**325 - 327 Deansgate – Manchester**

Non Material Amendment | 22 August 2022

10185-A-B5D8-RP-DAS-002

## 1.0 Introduction

### Roof Plan

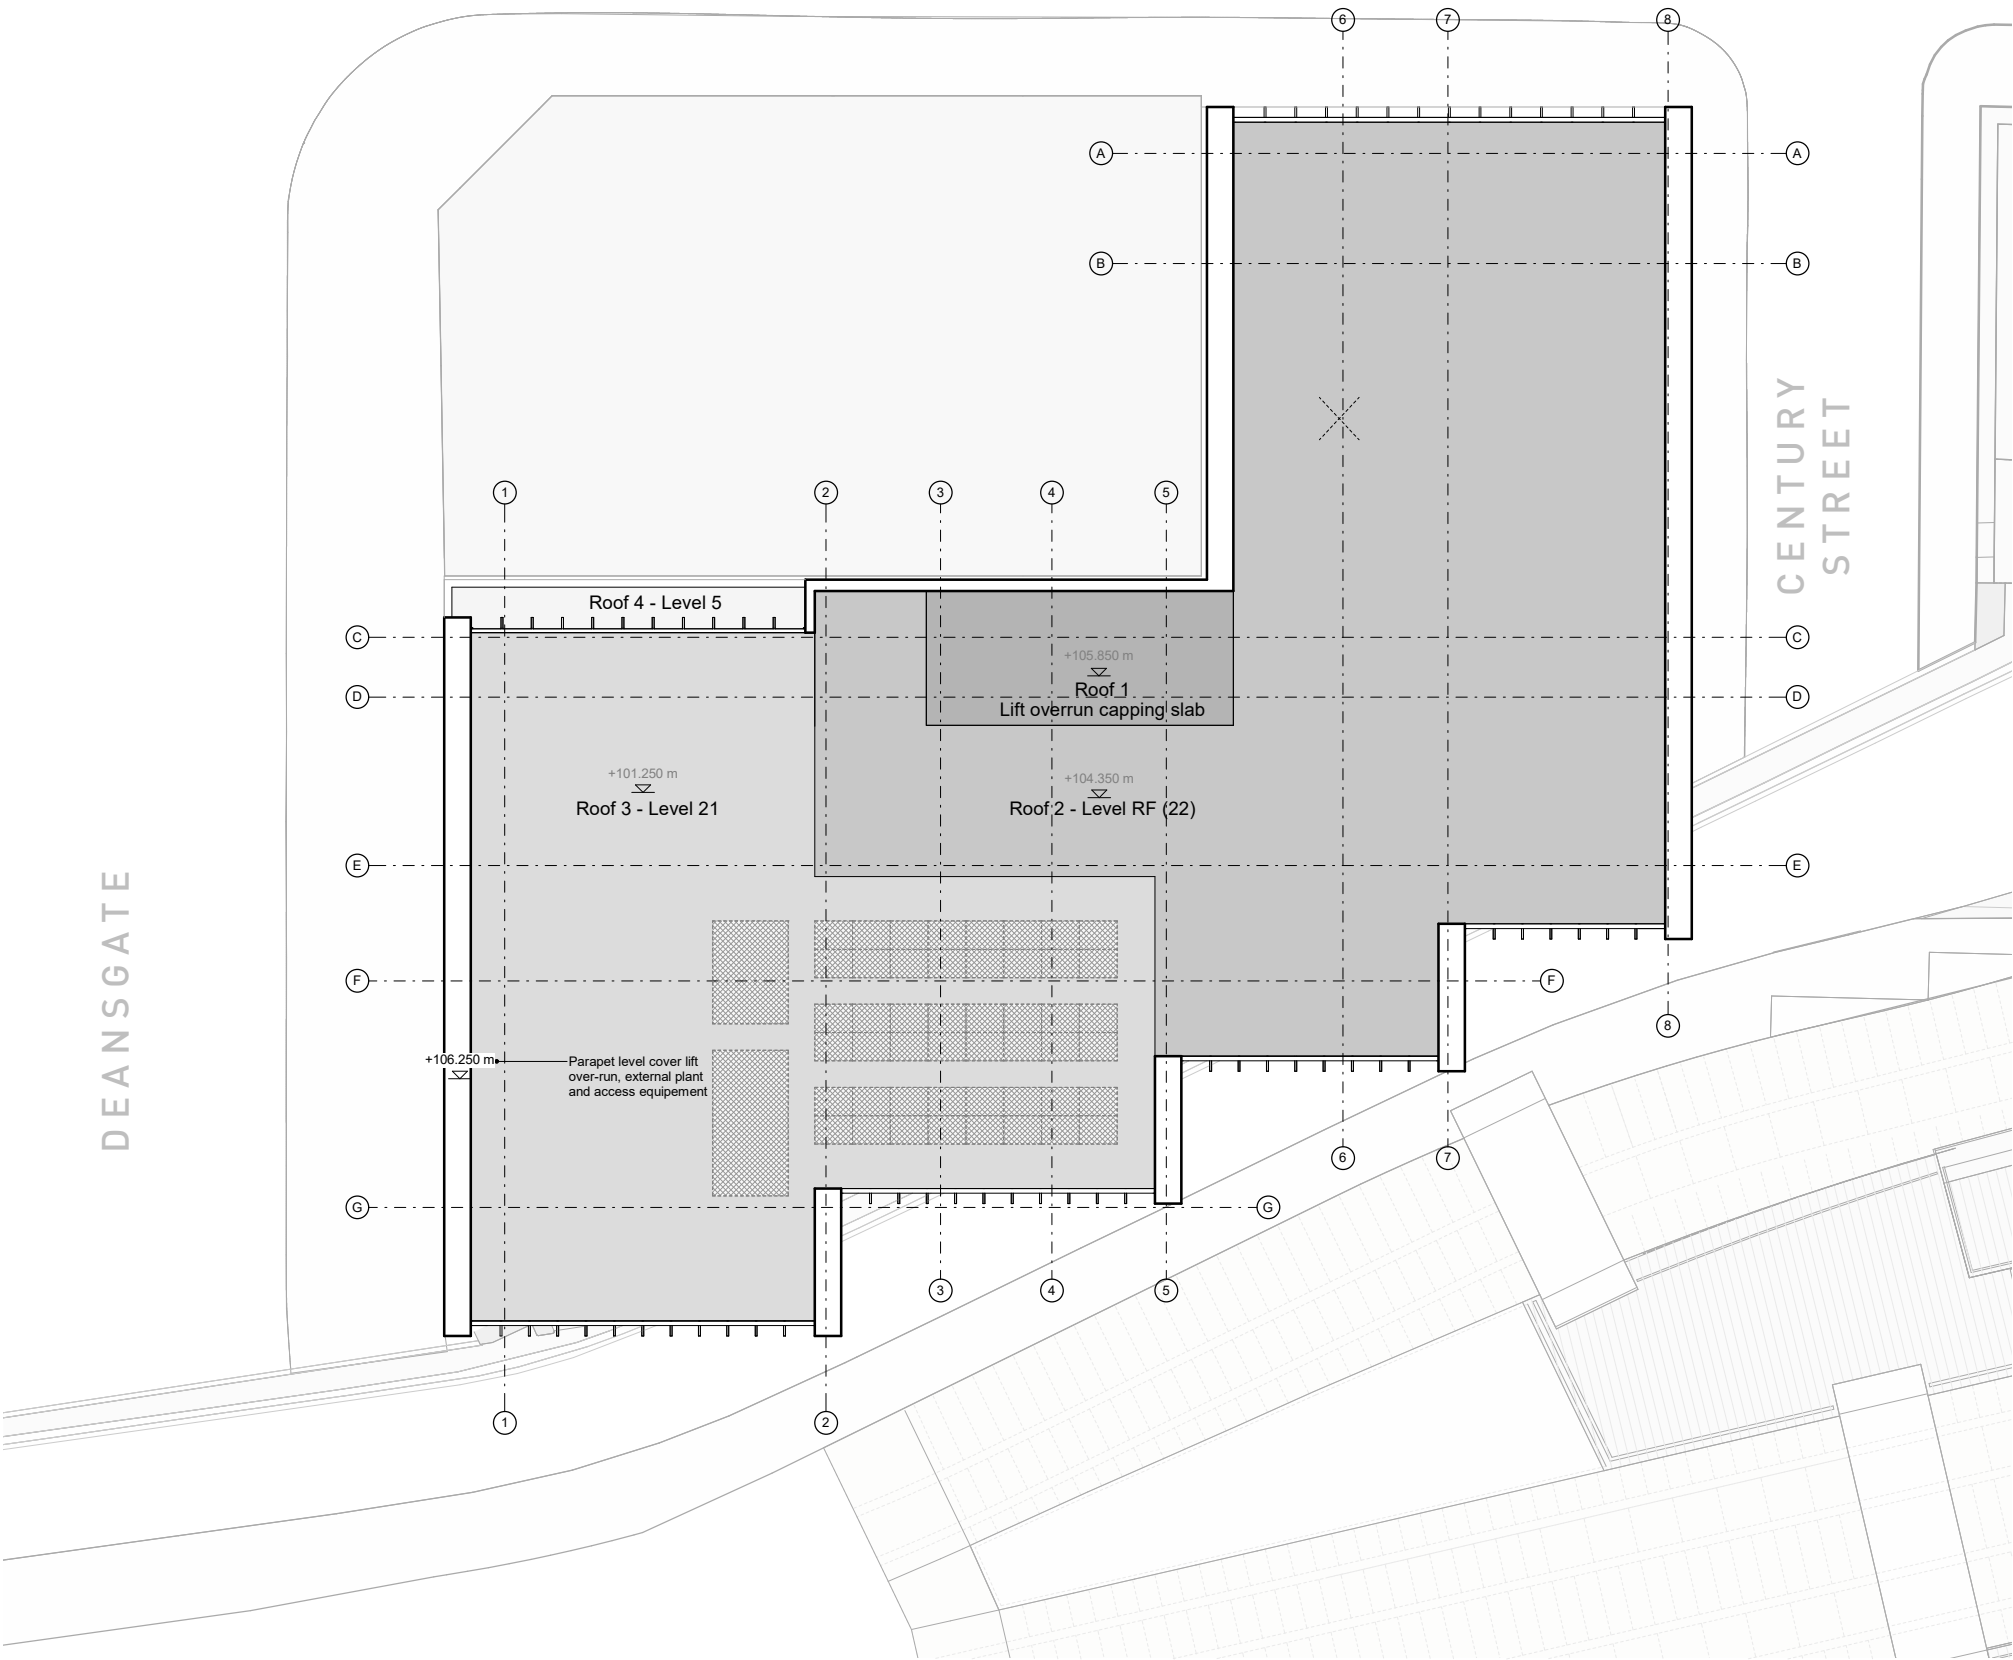
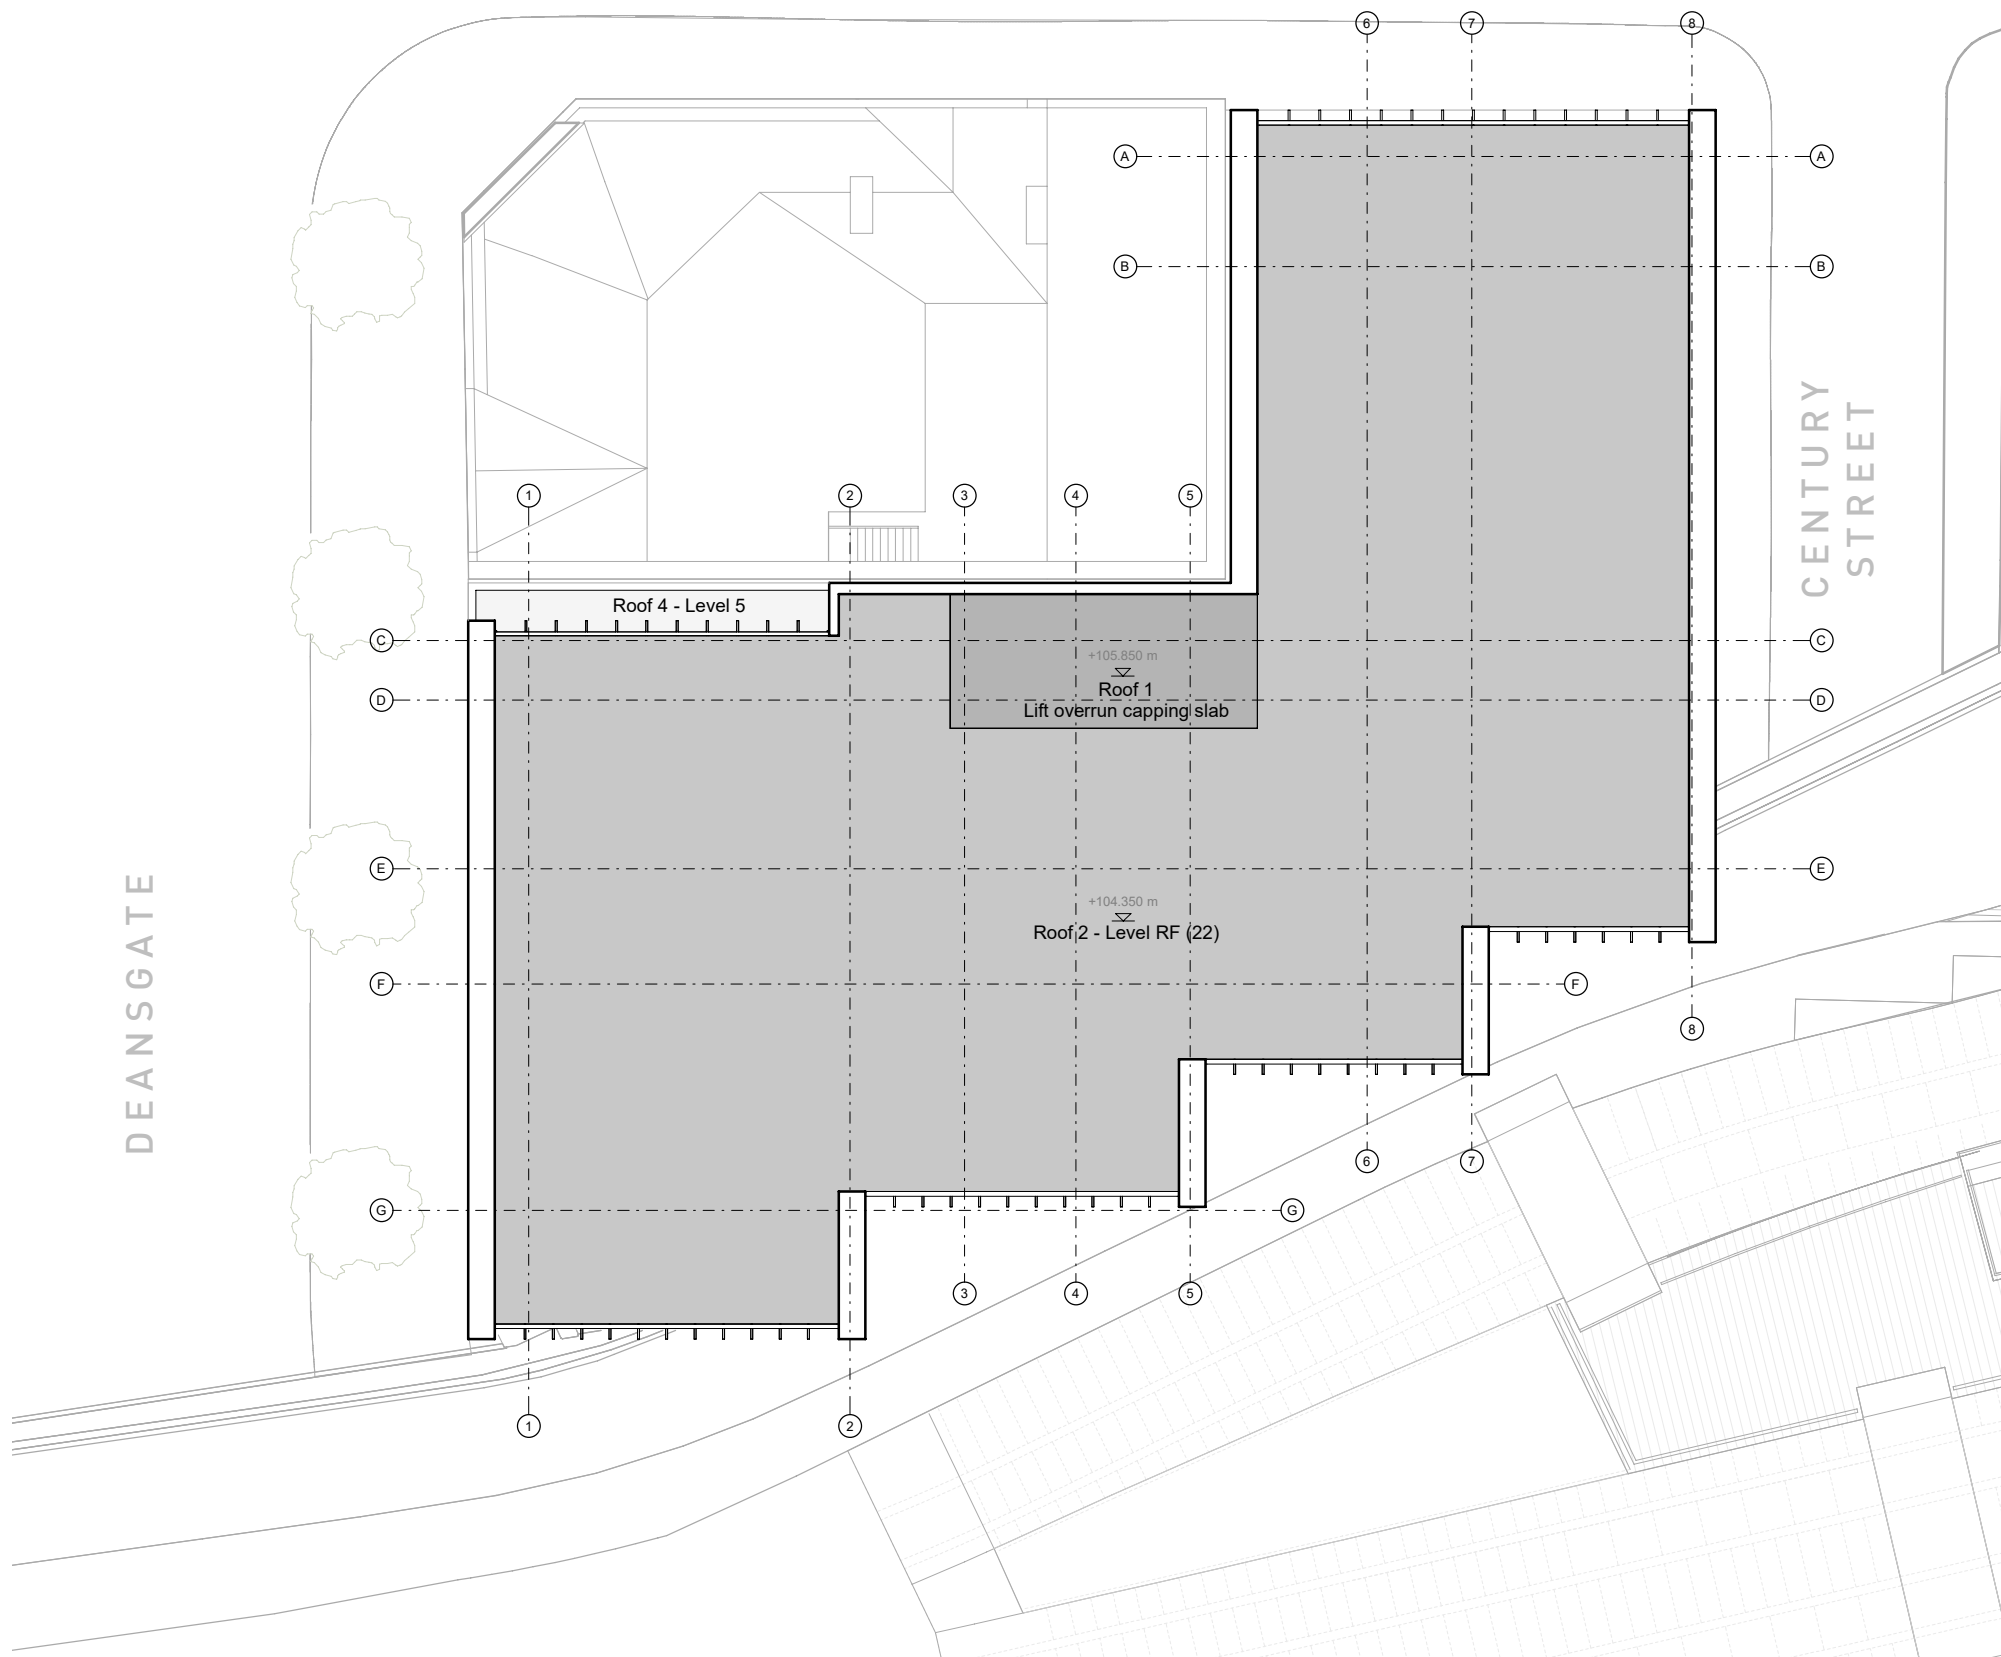
#### Amendments to Roof Plan

- Hotel rooms extended into space previously occupied by plant well.

## Section DD

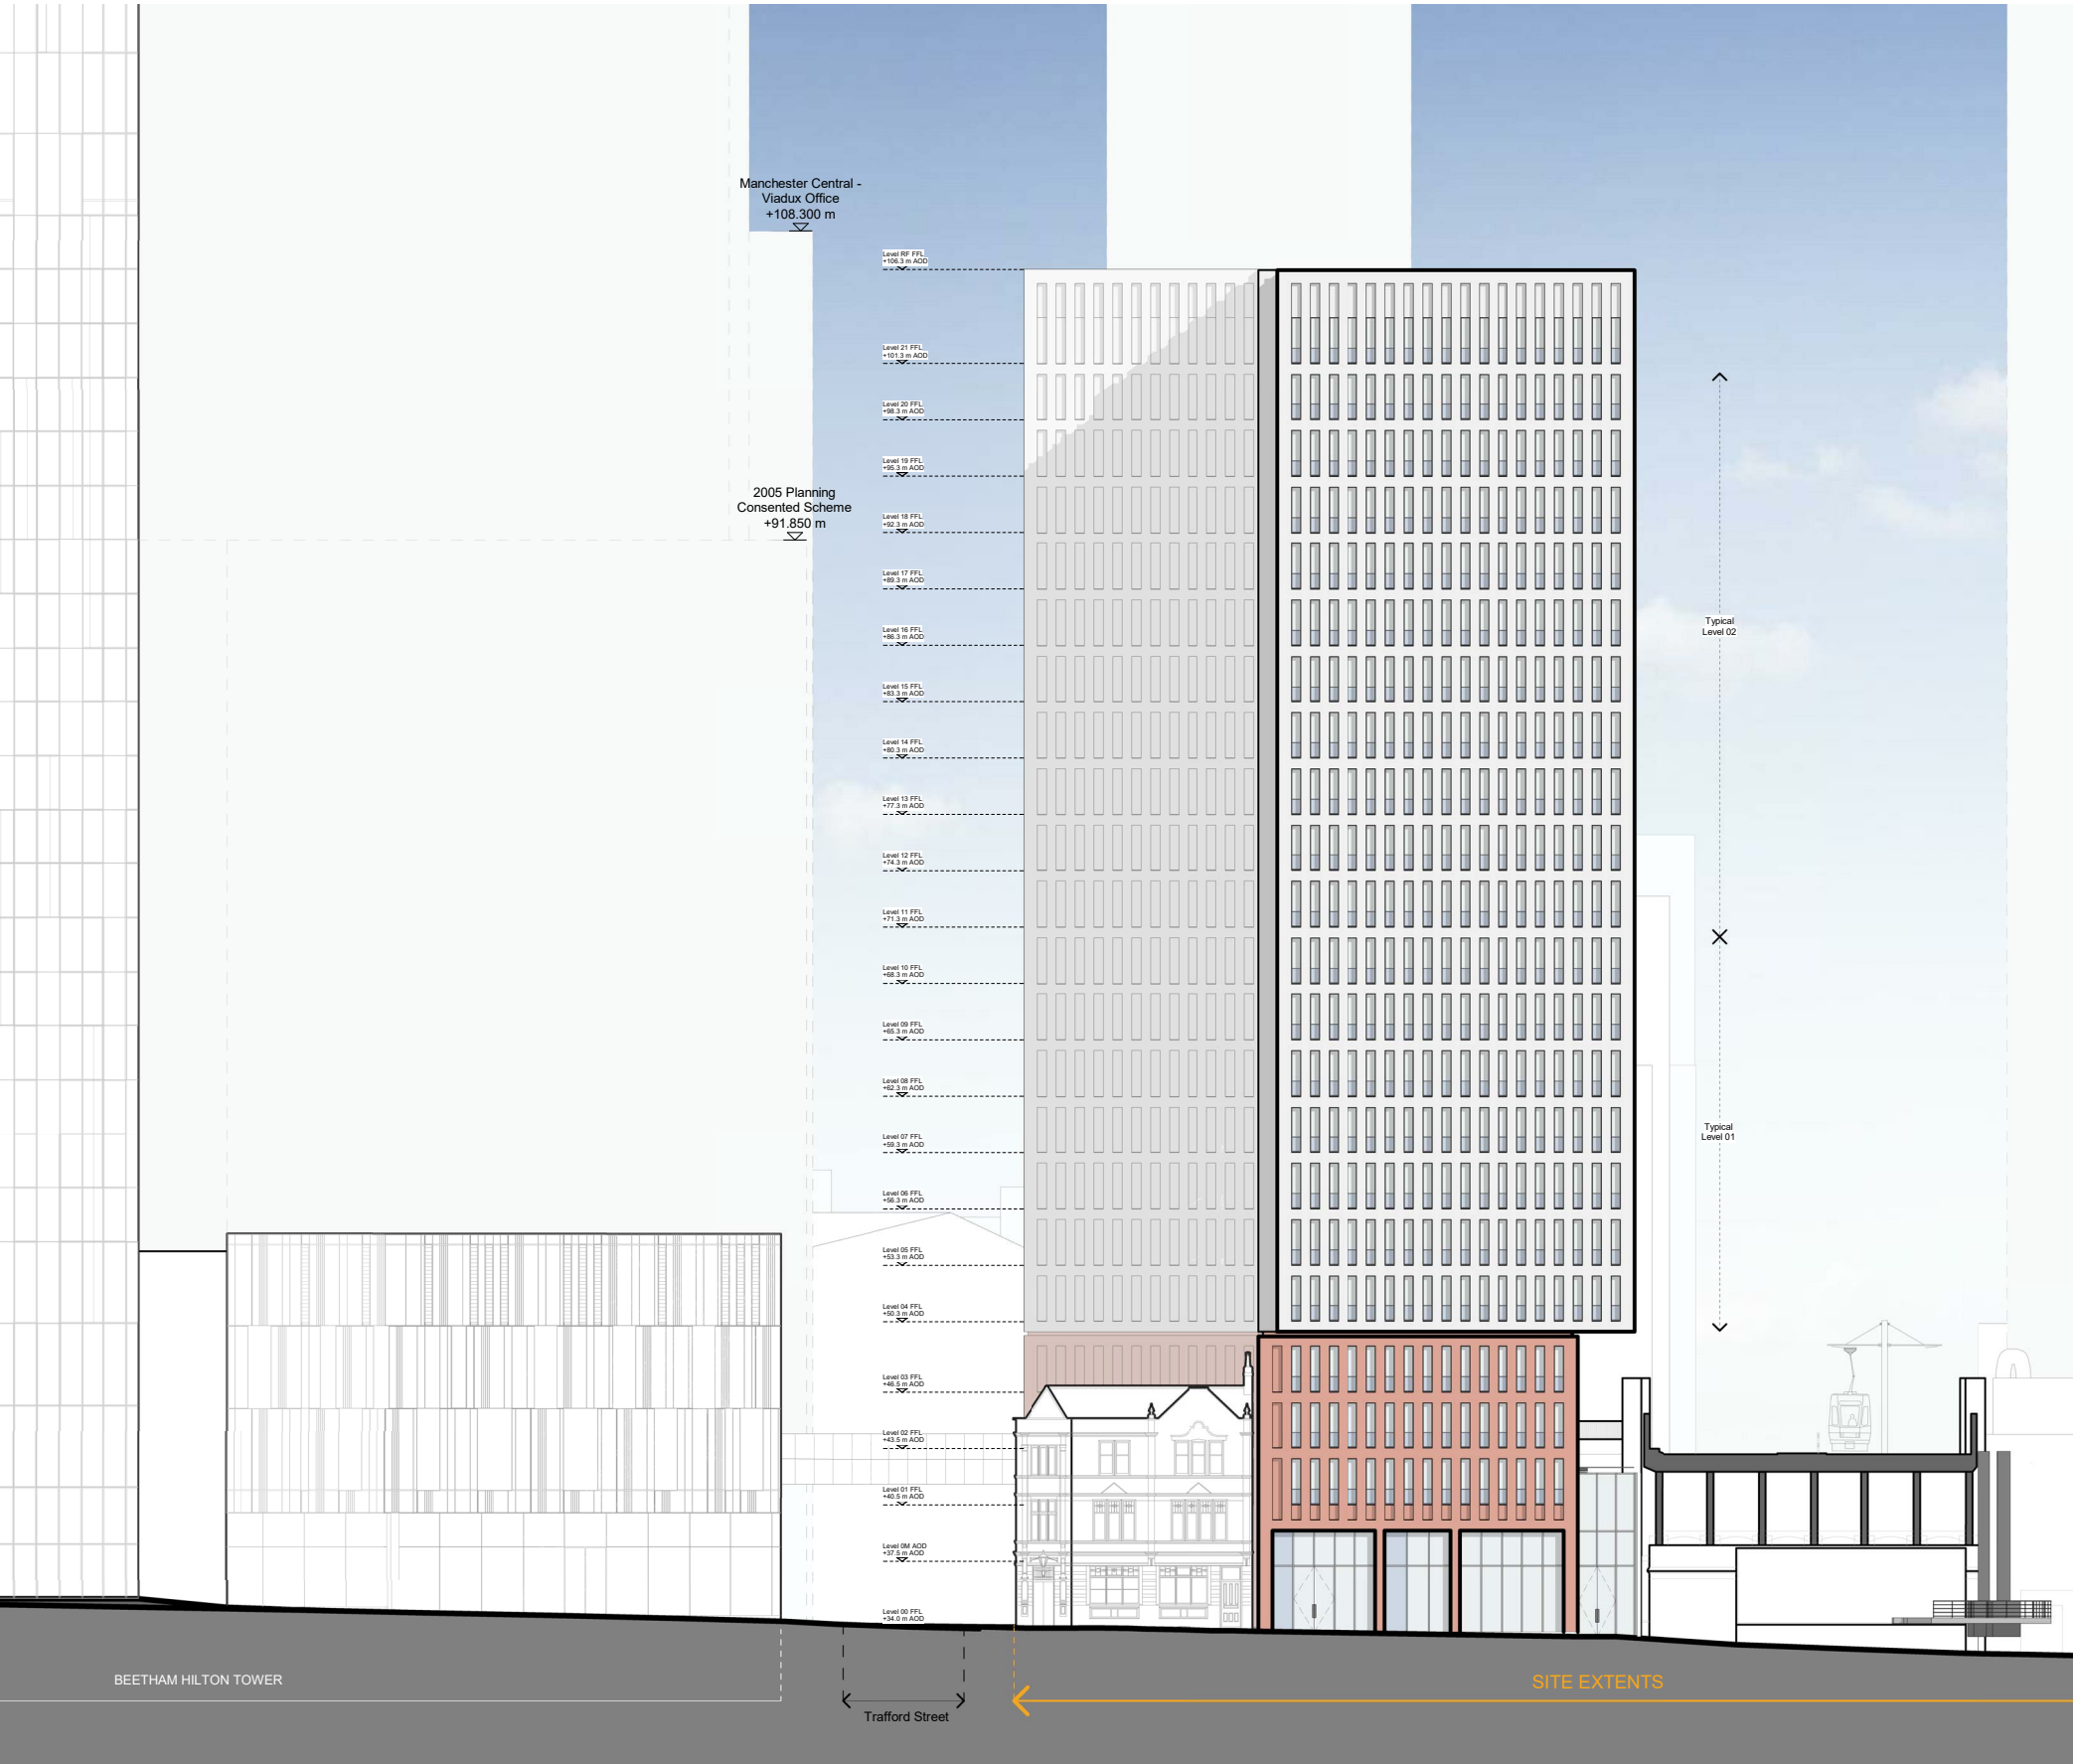
## Amendments to Section

- Retail unit omitted from arch closest to Deansgate. Hotel front of house areas extended into this space.
- Hotel rooms at level 21 extended into space previously occupied by plant well.
